#### **ADDENDUM NO. 004**

Brighton Wastewater Treatment System Upgrades

June 2, 2025

A805

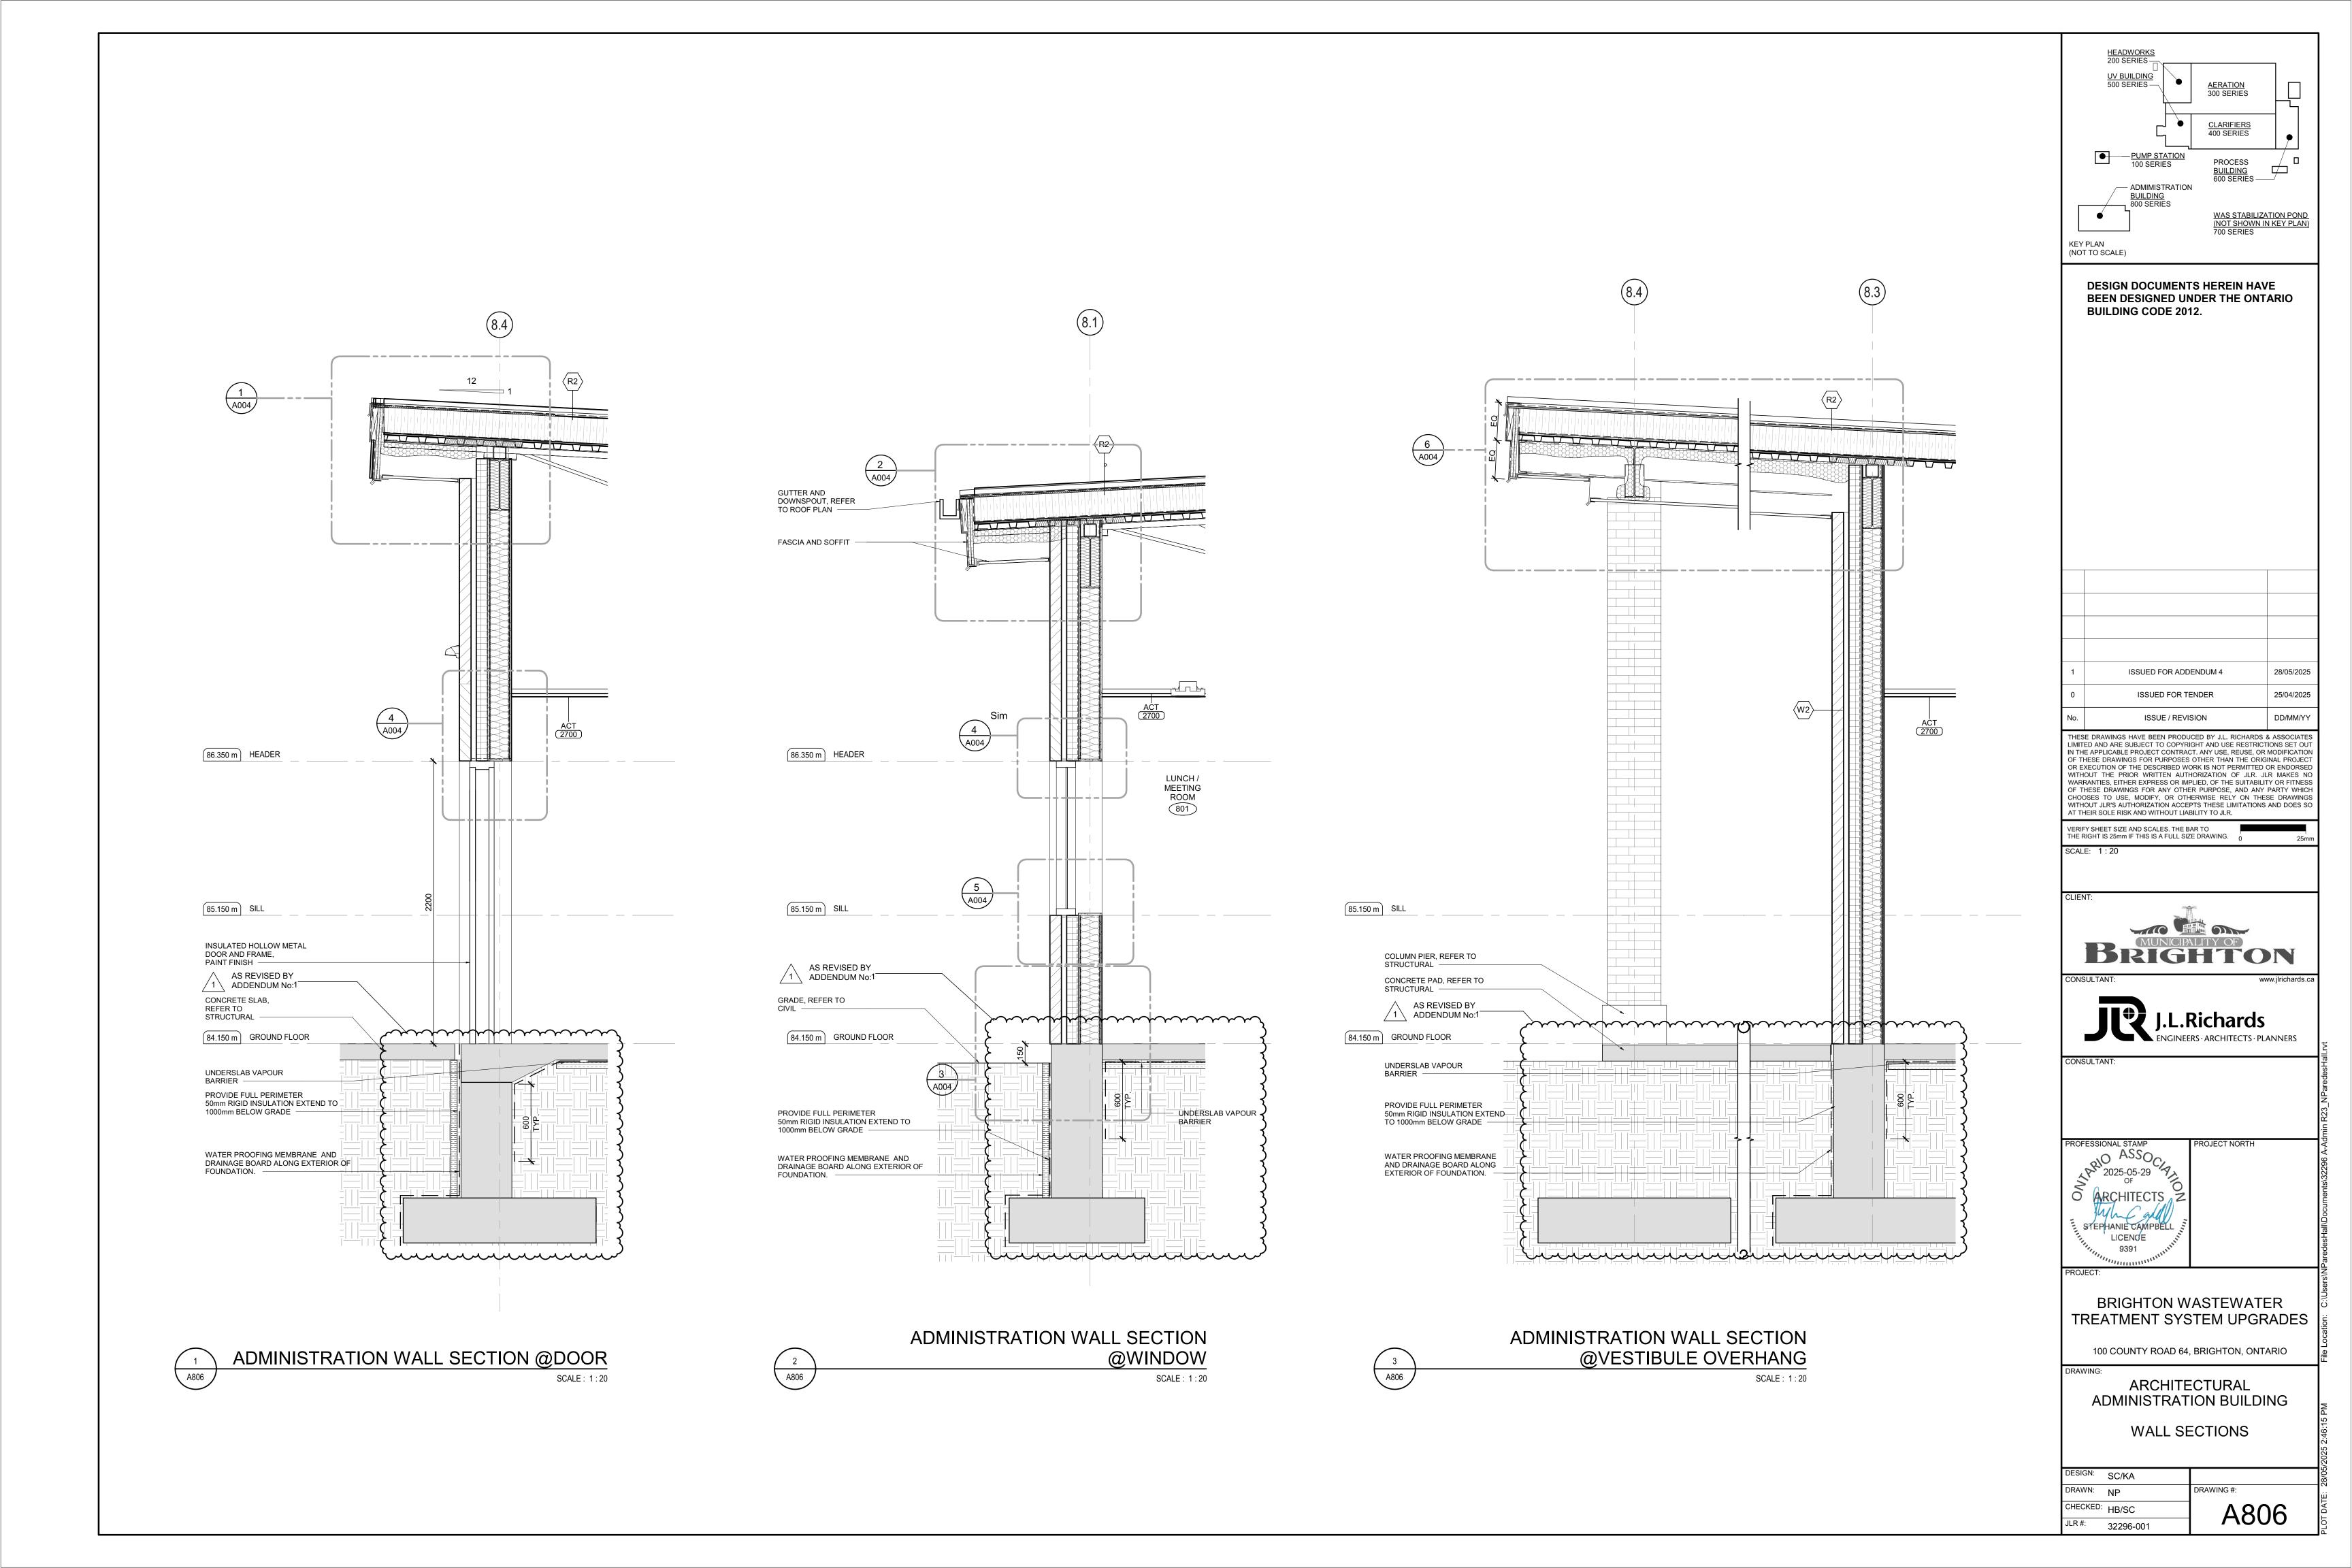
- 19.1 Detail #1 and #2
  - .1 **Revise** below grade waterproofing extension as bubbled.
  - .2 **Add** detail 1/A004, 2/A004, 3/A004, 4/A004 and 5/A004 callout.
